**POST-CLOSURE INSPECTION FORM
MARJOL BATTERY SITE, THROOP, PENNSLYVANIA**

Date of Inspection: November 19, 2010 **Day of Inspection:** Friday **Time Started:** 1000 **Time Completed:** 1200

Attendees: Kevin O'Rourke, Jamie Heimbach, Lisa Ayers (AGC), Arnie Boyer (SCE), Len Zelinka (PADEP)

POST CONSTRUCTION STORMWATER MANAGEMENT PLAN - FACILITY

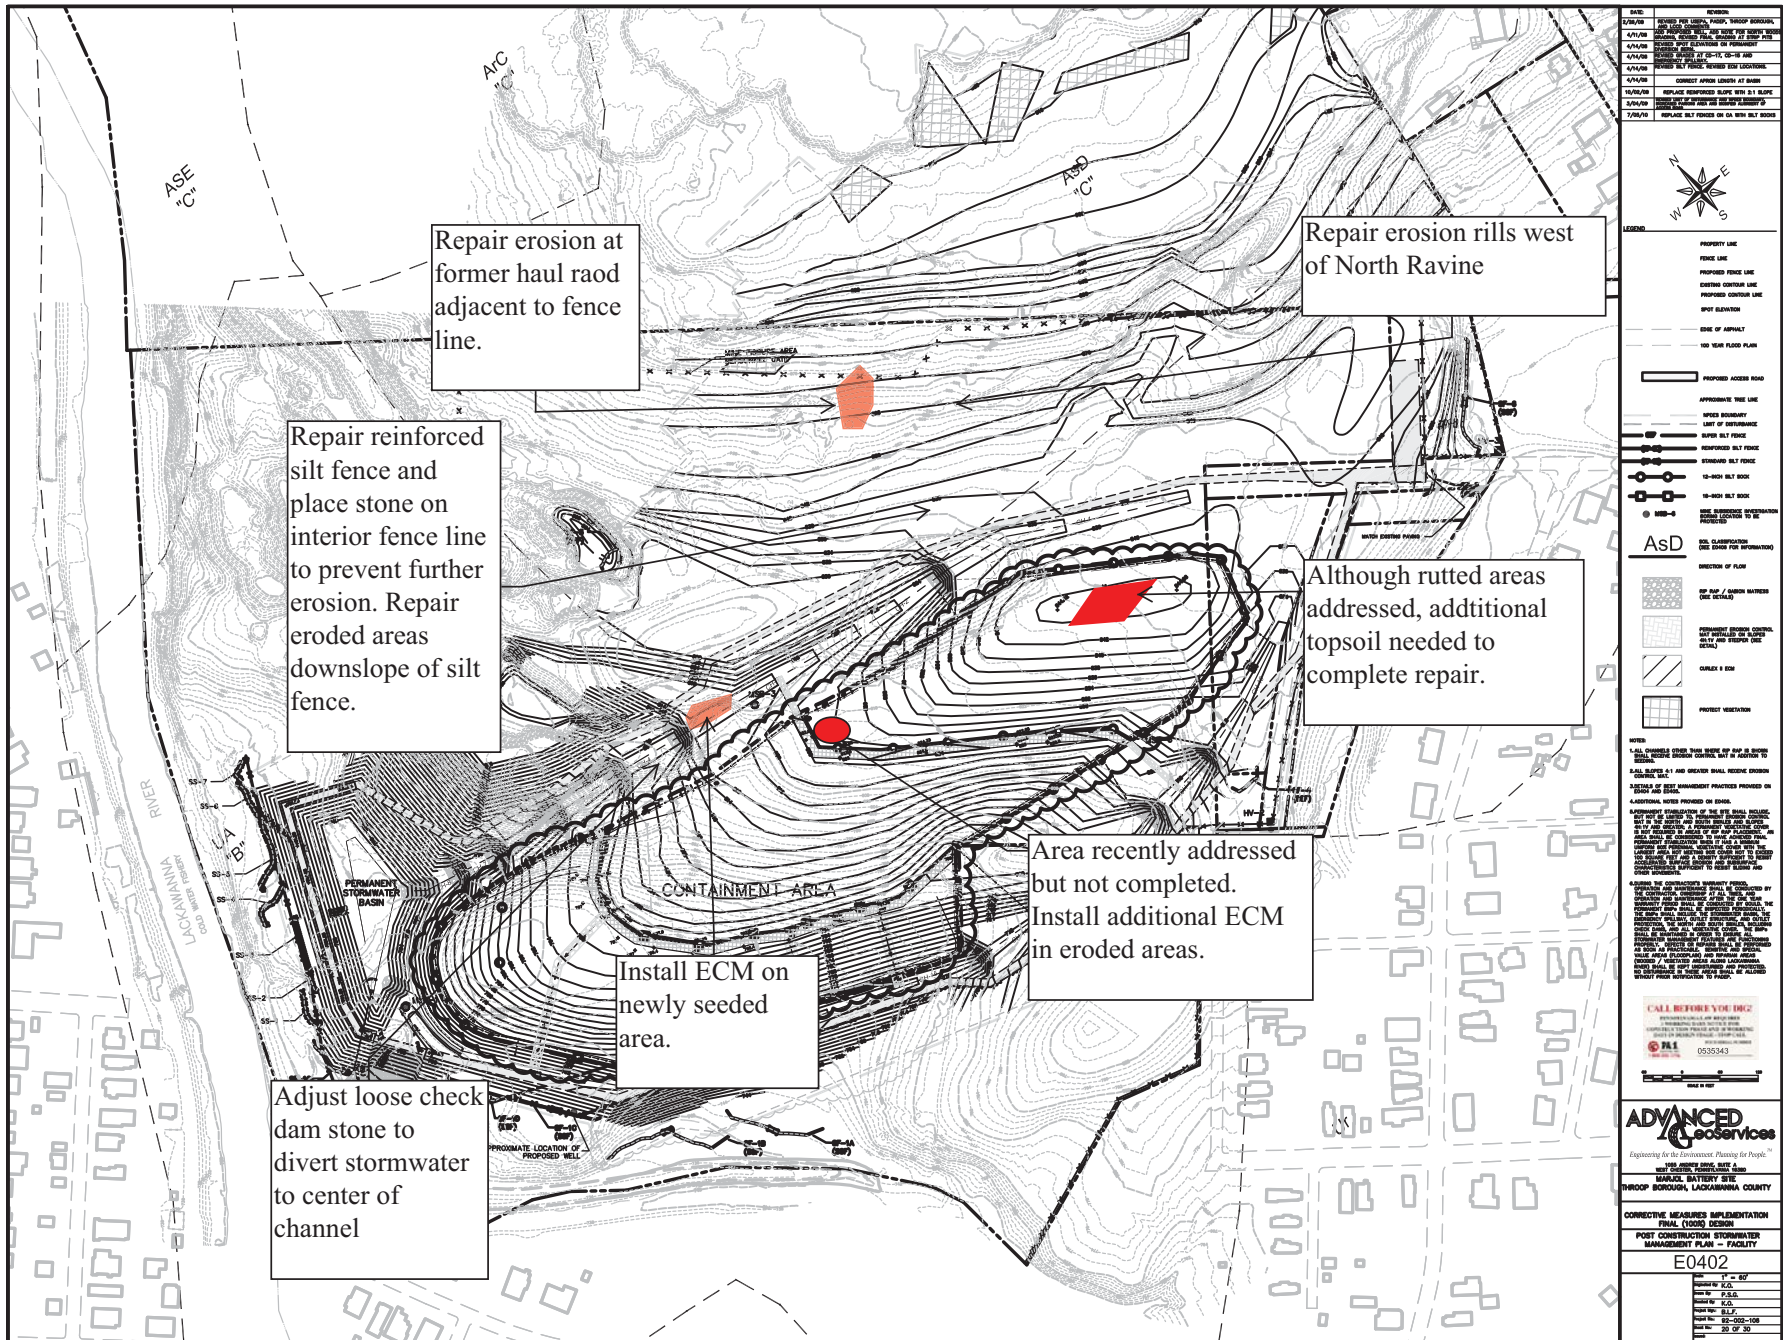
ITEM	Y / N	COMMENTS	MARK IF REPAIR NEEDED
<i>Containment Area Cap</i>			
Has proper vegetative cover been established? (at least 90 percent surface area coverage of live, growing species, with the largest individual surface area not meeting the 90 percent coverage requirement not to exceed 100 square feet)	No	Additional coverage needed on the eastern areas of the CA. Steep slope and western areas have improved. Recent seeding has germinated and new grass growth is continuing.	
Are trees, shrubs or deep rooted plants present on the cap?	No		
Is additional seeding, mulching or watering needed?	No	Soil is moist from recent rain events. No additional water needed at this time. Additional ECM to be placed north of top bench as shown on attached sketch.	X
When was mowing last conducted?		October 23, 2010. No need for additional mowing at this time.

ITEM	Y / N	COMMENTS	MARK IF REPAIR NEEDED
Have significant changes in vegetative cover occurred (color, density, height, overall health)?	Yes	Density of grass growth has increased since last inspection (October 22, 2010) and reseeded. Germination has occurred on newly reseeded areas.	
Is the integrity and effectiveness of the Containment Area soil cover acceptable?	Yes	No issues noted	
Are significant erosion rills or soil cracking present?	No		
Is ponding present? If yes, note depth.	Yes	Small puddles with less than one inch depth on benches.	
Is settlement or subsidence visible?	No		
Are Containment Area slopes visually stable?	Yes		
Are cap drain outfall pipes free of blockage?	Yes	Sediment removed from outfall identified during last inspection.	
Are the geosynthetics visible?	No		
Is any waste material exposed?	No		
Is there a visible change in the designed drainage pattern?	No

ITEM	Y / N	COMMENTS	MARK IF REPAIR NEEDED
Is damage from burrowing animals present?	No		
Are the silt socks in the CA functional?	Yes		
Is erosion occurring under the silt socks?	Yes	Minor erosion in specific points. Grass growth density is increasing causing less erosion beneath socks.	X
<i>Restored Excavation Areas</i>			
Has proper vegetative cover been established? (at least 90 percent surface area coverage of live, growing species, with the largest individual surface area not meeting the 90 percent coverage requirement not to exceed 100 square feet)	No	Areas of the Site (North woods) have the required coverage except former haul roads. The Facility portion is improving.	
Is additional seeding, mulching or watering needed?	No	Areas of the site with less than required coverage were reseeded on October 22, 2010.	
When was mowing last conducted?		October 23, 2010. No need for additional mowing at this time.

Have changes in vegetative cover occurred?	Yes	Vegetation on slope above former support zone has increased.

ITEM	Y / N	COMMENTS	MARK IF REPAIR NEEDED
Are significant erosion rills or soil cracking present ($\geq 9''$)?	No	Minor rills in North Ravine area less than 9 inches.	X
Is ponding present? If yes, note depth.	Yes	Minor puddles downstream of permanent diversion berm.	
Is settlement or subsidence visible?	No		
Are slopes visually stable?	Yes		
Are erosion and sedimentation controls functioning properly? (silt socks, silt fence, RCE, etc.)	Yes	Repair to silt fence south of temporary stockpiles needs to be addressed.	X
<i>Access Roads</i>			
Are significant cracks, potholes, or erosion present?	No		
Is the roadway in adequate working order?	Yes		
<i>Fencing</i>			
Is the fence rusted or deteriorated?	No	New split rail fence and gates recently completed.

ITEM	Y / N	COMMENTS	MARK IF REPAIR NEEDED
Is the fence cut or breached?	No	Temporary chain link at split rail fence gap to be secured more effectively.	X
Is burrowing or tunneling present under the fences?	No		
Are all gates and locks operating?	Yes		
Are required signs present?	Yes	Additional "Posted Private Property" signs to be installed.	
Are there any signs of trespassing, including the North Woods Trails?	No		
<i>Stormwater System</i>			
What is the water level in the stormwater basin?		Approximately 4 feet.	
Are there indications of animal activity?	No	Geese and Ducks using the basin.	
Is adequate vegetation present?	Yes		
Is erosion occurring in the basin or channels?	Yes	Erosion occurring at CD-7 where the North Swale enters the basin. Repairs required.	X

ITEM	Y / N	COMMENTS	MARK IF REPAIR NEEDED
Are basin slopes visually stable?	Yes		
Has blockage or clogging occurred in channels, inlets or the discharge pipe?	No		
Are sediments present in channels, inlets or the basin? If yes, note depth.	Yes	Basin sediment is present but not enough to require removal at this time.	
Are rip rap channel linings / gabion mattresses in adequate working order?	No	CD-7 requires repair to the gabion mattress at the top of the check dam.	X
Are check dams in adequate working order?	No	Adjustment of stone check dams located below CD-3 to divert stormwater flow to center of channel.	X
Is there water present in the North Woods Low Area? If yes, note depth.	No		
Is the North Woods Low Area drainage system functioning properly?	Yes		
Is vegetation established in the North Woods Low Area?	Yes	Stone installation disturbed existing growth. Areas reseeded and stabilized.
